ENERGY STAR® Set-top Boxes Final Draft Specification Webinar

May 10, 2016

ENERGY STAR Products Labeling Program

Sleep Modes Diagram

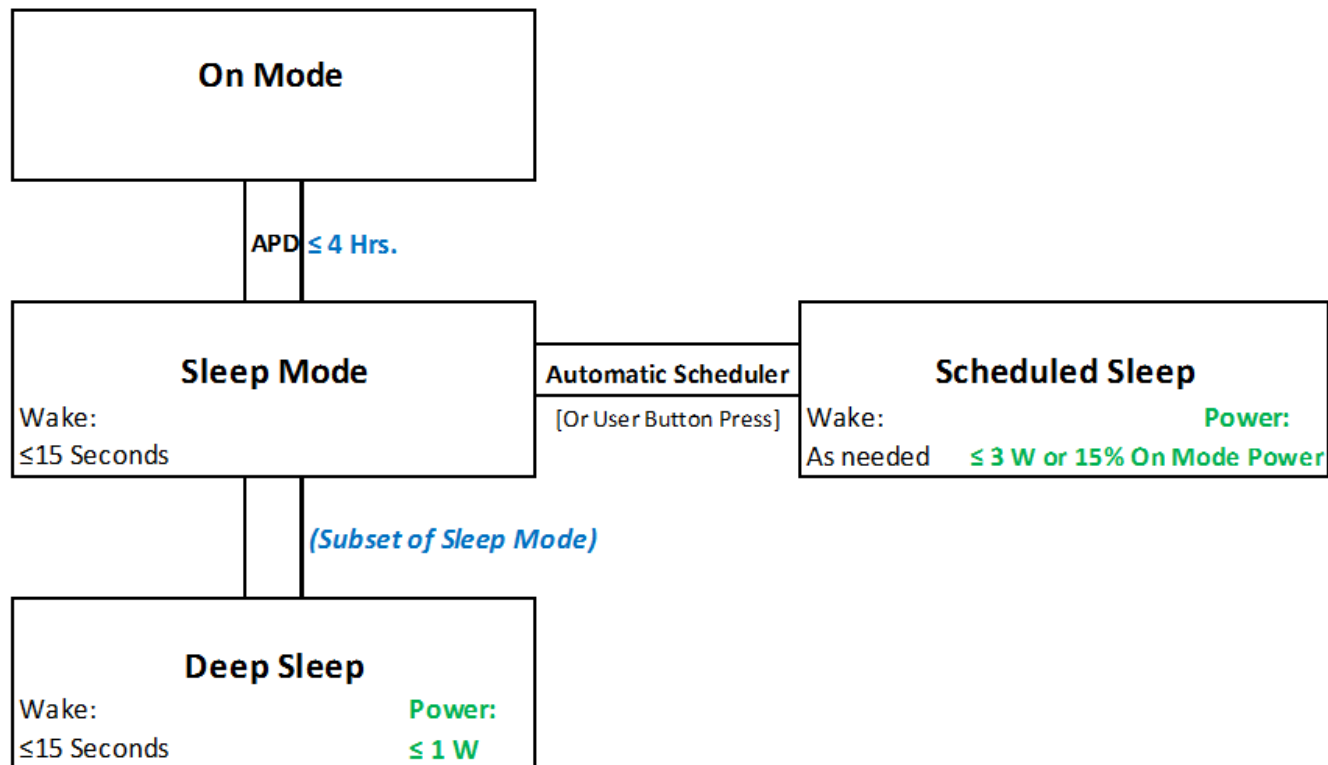
- A stakeholder requested clarification with the different requirements for Sleep Mode, Deep Sleep, and Scheduled Sleep.
